# **Pentium® Processor Specification Update**

Release Date: April, 1997

Order Number 242480-026

### 2. ***Incorrect TCP Pinout Drawing***

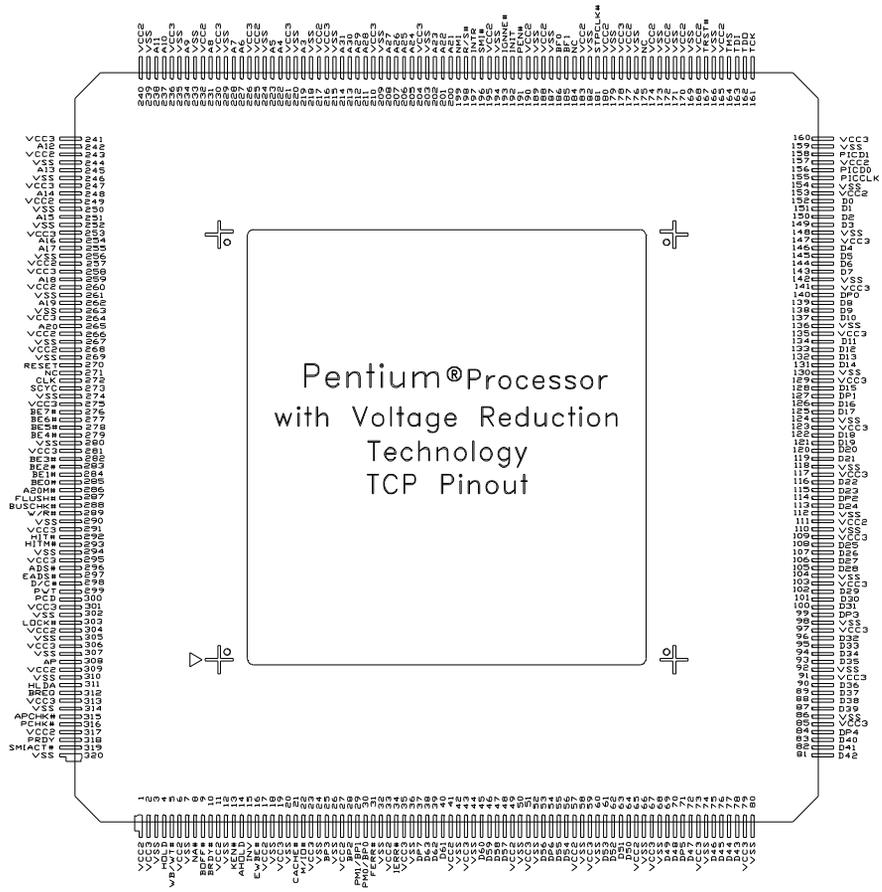
The TCP pinout drawing on page 8 of the Pentium Processor with Voltage Reduction Technology datasheet was inadvertently rotated. The correct orientation is shown below.

Figure14-1. Maximum Undershoot Level, Undershoot Threshold Level, and Undershoot

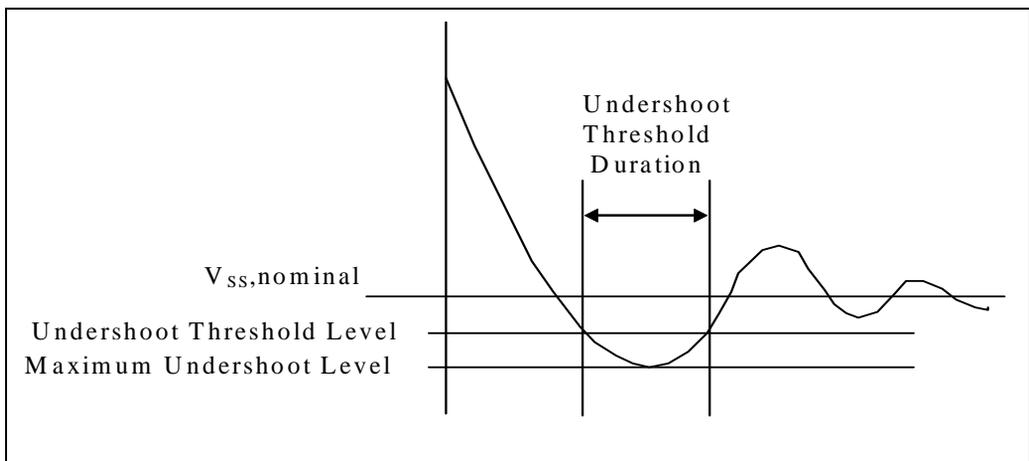
**MAXIMUM RINGBACK SPECIFICATION:** The maximum ringback of CLK associated with its low state (undershoot) must not exceed 0.8V as shown in Figure 14-1.

**UNDERSHOOT THRESHOLD DURATION SPECIFICATION:** A snapshot of the clock signal should be taken at 500 mV/div and 500 pS/div (for CLK). Adjust the vertical position and horizontal offset position to view the threshold duration. The undershoot threshold duration is defined as the sum of all time during which the clock signal is below -0.5V within a single clock period. The undershoot threshold duration must not exceed 20% of the period.

This undershoot specifications are illustrated graphically in Figure 14-1 and Figure 14-2.

Figure 14-2. Maximum Ringback Associated with the Signal Low State

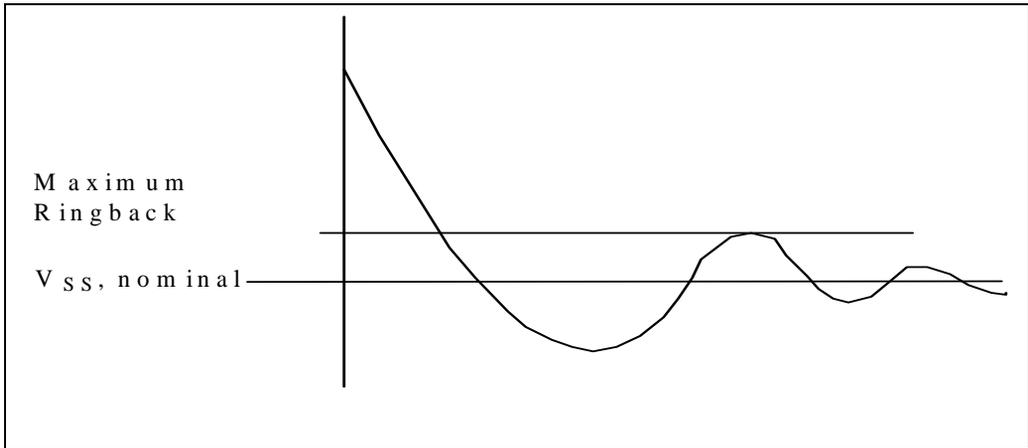
**MAXIMUM UNDERSHOOT AND MAXIMUM RINGBACK SPECIFICATIONS:** The display should show continuous sampling (e.g., infinite persistence) of the waveform at 500 mV/div and 5 nS/div (for CLK) for a recommended duration of approximately five seconds. Adjust the vertical position to measure the maximum undershoot and associated ringback. There is no allowance for crossing the maximum undershoot or maximum ringback specifications.
